Report: Issue Data
Function: Test, Adjust, & Balance
Date: 12/04/2025
Completed By: National TAB

PROJECT
CW 8950 - Mr Cooper (Coppell, TX)

Project: CW 8950 - Mr Cooper (Coppell, TX)

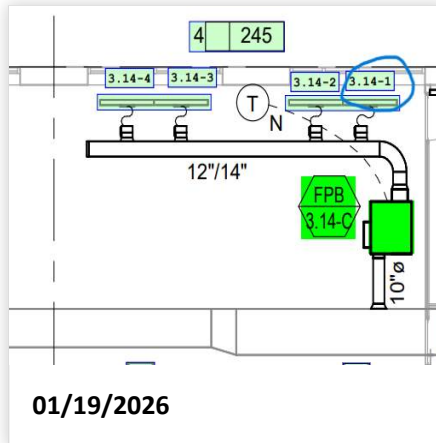
Issue Name : FPB3.14C Missing Diffuser
Description : Missing diffuser #1 in space. A side 3rd floor Open Office 313.
Created By : National TAB **Assigned To :** National TAB - Stephan Gabbert
Status : Open
Priority : Urgent **Asset Tag :**
Originated Date : 01/19/2026 - Bayley Morvant - National TAB

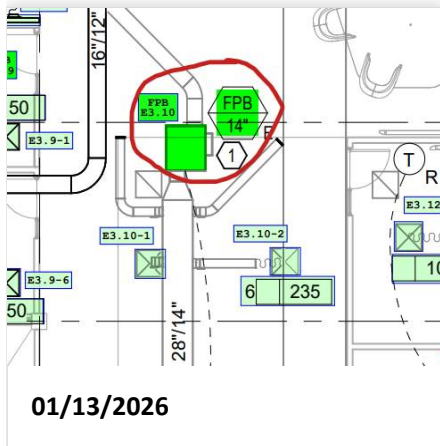
Issue Name : FPBE3-10 Fan Not Operational
Description : Fan not operational during time of testing. Unit is an existing box. (controls label is FPB3-38)
Created By : National TAB **Assigned To :** National TAB - Stephan Gabbert
Status : Open
Priority : Urgent **Asset Tag :**
Originated Date : 01/13/2026 - Bayley Morvant - National TAB

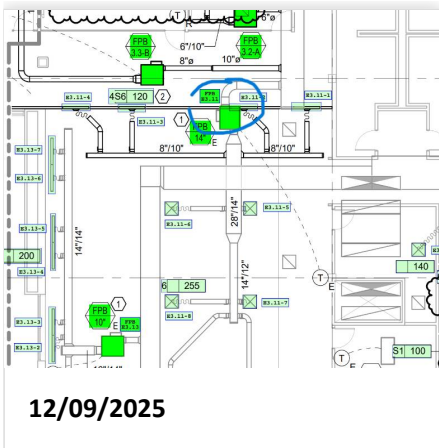
Issue Name : FPBE3-11 Fan Not Operational
Description : FPB3E3-11 fan is not operational. Unit is an existing box. (Controls label is FPB3-51)
Created By : National TAB **Assigned To :** National TAB - Stephan Gabbert
Status : Open
Priority : **Urgent** **Asset Tag :**
Originated Date : 12/09/2025 - Bayley Morvant - National TAB

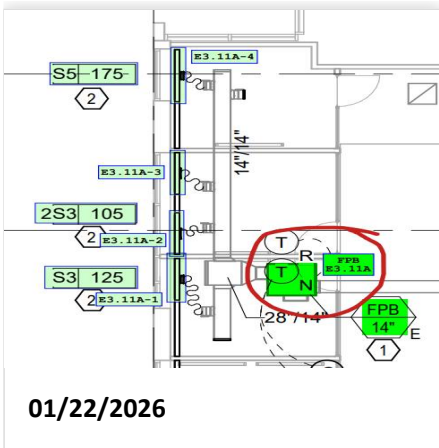
Issue Name : FPBE3.11A Fan Not Operational
Description : Fan not operational during time of testing. Unit is existing box. (box labeled as FPB3-14 on controls graphics)
Created By : National TAB **Assigned To :** National TAB - Stephan Gabbert
Status : Open
Priority : **Urgent** **Asset Tag :**
Originated Date : 01/22/2026 - Bayley Morvant - National TAB

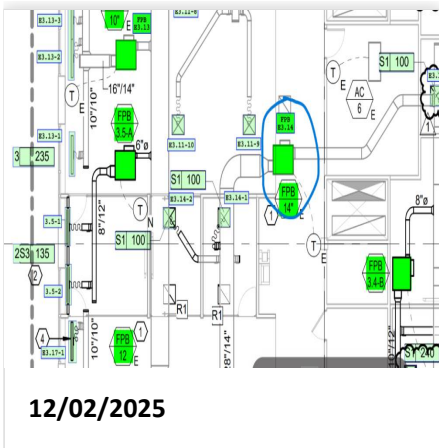
Issue Name : FPBE3.14 Fan not operational
Description : Fan not operational during time of testing. Unit is existing box. (box labeled as FPB3-48 on controls graphics)
Created By : National TAB **Assigned To :** National TAB - Stephan Gabbert
Status : Open
Priority : **Urgent** **Asset Tag :**
Originated Date : 12/02/2025 - Bayley Morvant - National TAB

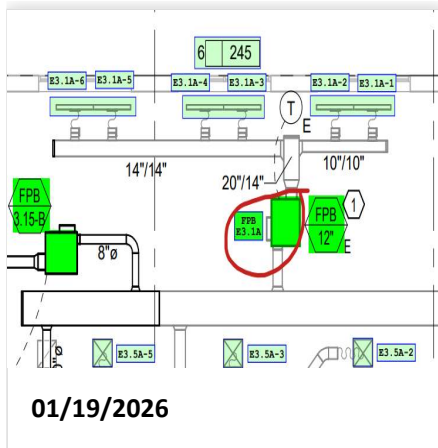
Issue Name : FPBE3.1A Fan Not Operational
Description : Unit fan not operational in heating mode. Unable to balance fan to design. Unit is an existing unit.
Created By : National TAB **Assigned To :** National TAB - Stephan Gabbert
Status : Open
Priority : Urgent **Asset Tag :**
Originated Date : 01/19/2026 - Bayley Morvant - National TAB
